Proposed Change 1775

Code Reference(s): NBC20 Div.B 1.1.3.1. (first printing)
NBC20 Div.B Appendix C (first printing)

Subject: Structural Design (Part 9)

Title: Seismic Hazard Values for the Design of Part 9 Buildings

Figure [\[A-1.1.3.1.\(4\)\]](#) A-1.1.3.1.(4)

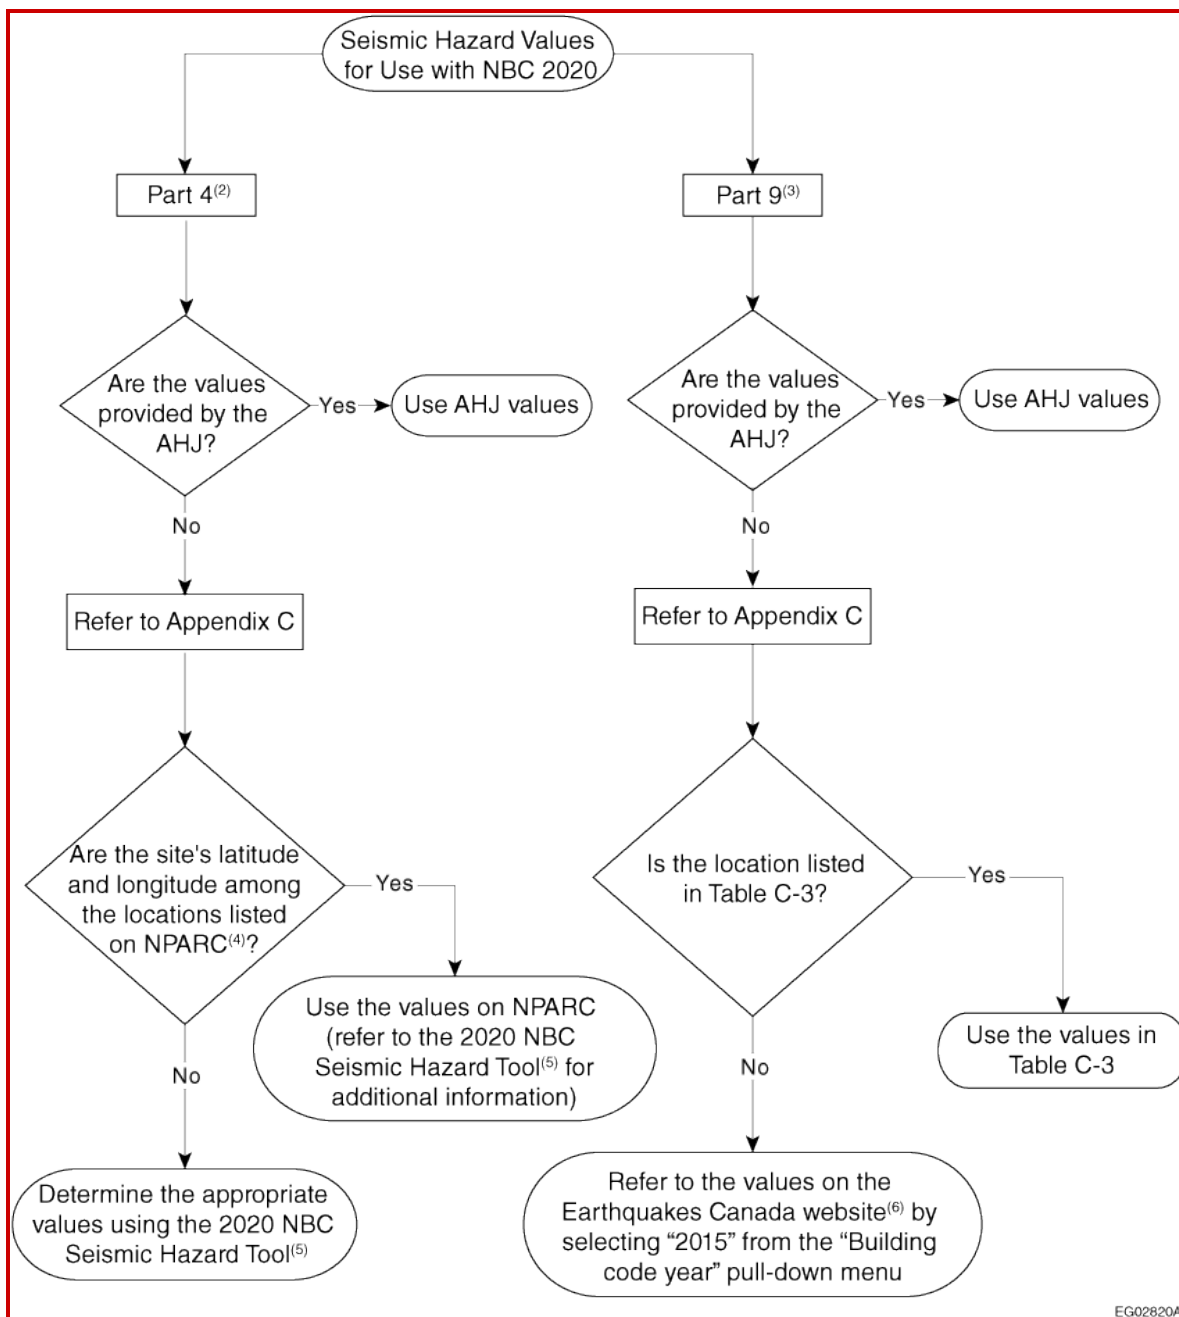
Note A-1.1.3.1.(4) Seismic Values.

Figure A-1.1.3.1.(4) illustrates how to determine the seismic hazard values to be used in the application of the Part 4 and Part 9 seismic provisions.

Figure 1: Graph of impacts on all locations

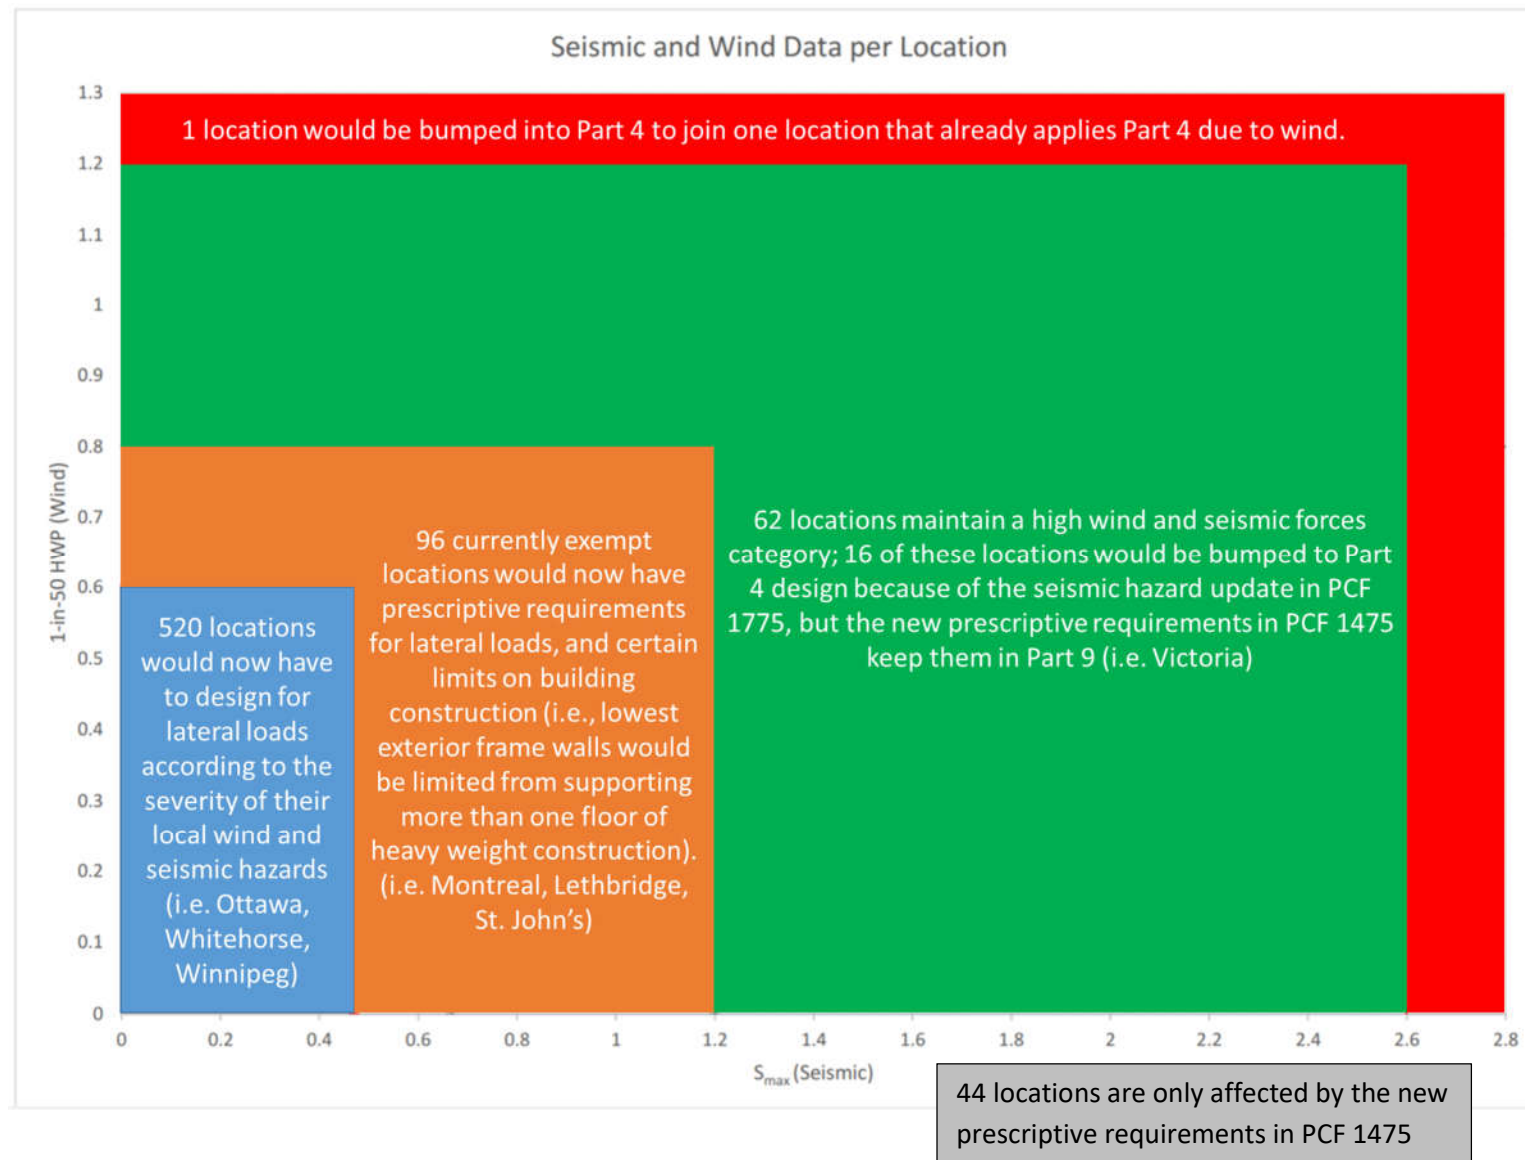
There are 520 locations that are currently exempt (in the NBC 2020) from lateral load bracing requirements (refer to **Appendix A** and **Figure 1**, blue shading), but now would not be and would apply the new prescriptive requirements in PCF 1475, which are proportionate to the severity of the expected local wind and seismic hazards.

There are 96 locations that are currently exempt (in the NBC 2020) from lateral loads bracing requirements (refer to **Appendix B** and **Figure 1**, orange shading), but now would not be and would apply the new prescriptive requirements according to the severity of their local wind and seismic hazards. As well, the lowest exterior framed walls for buildings in these locations are limited from supporting more than one floor of heavy weight construction.

In the NBC 2020, there are 63 locations that apply the requirements for high wind and seismic forces, and 62 of these locations remain in this category (refer to **Appendix C** and **Figure 1**, green shading) with no change to the limit of how many floors of heavy weight construction are permitted to be supported by the lowest exterior framed wall. The other location (refer to **Figure 1**, red shading) is bumped to Part 4 because of the seismic hazard update in PCF 1775.

PCF 1475 expands the application of Part 9 and keeps 16 locations (refer to **Figure 1**, green shading) from being bumped into Part 4 by the seismic hazard update in PCF 1775.

One location whose wind loads are beyond Part 9 application in the NBC 2020 remains beyond Part 9 application despite changes to thresholds in PCF 1475 (refer to **Figure 1**, red shading).

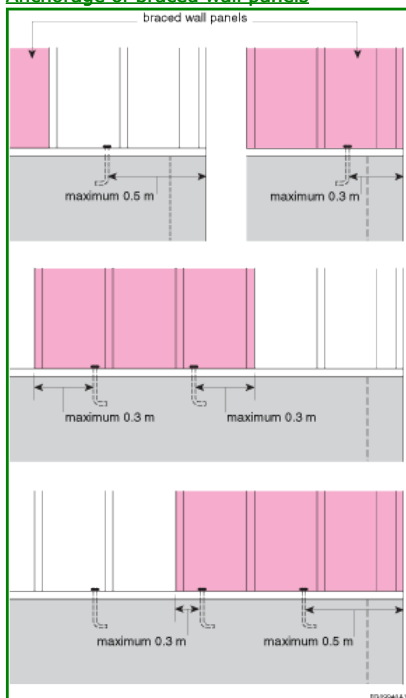
[6] 6) Where the seismic spectral acceleration, $S_a(0.2)$, is greater than 1.8 or the 1-in-50 hourly wind pressure is equal to or greater than 1.2 kPa, ~~a~~ Anchorage shall be designed according to Part 4, ~~where~~

[a] --) the 1-in-50-year hourly wind pressure (HWP) is greater than 1.2 kPa,

[b] --) the seismic design parameter, S_{max} , is greater than 2.6, or

- [c] --) the seismic design parameter, S_{max} , for Site Class C is greater than 0.47, for *buildings of 3 storeys in building height and*
- [i] --) of heavyweight construction,
- [ii] --) clad at full height with masonry veneer, or
- [iii] --) clad at full height with stone veneer
- (see Sentence 9.23.13.2.(3)).

Foundation cripple wall where $S_{max} \leq 0.60$

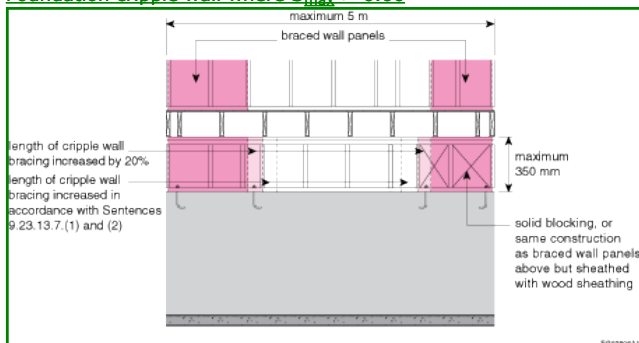
Note A-9.23.13.8.(2) Foundation Cripple Walls Where $S_{max} \leq 0.60$.
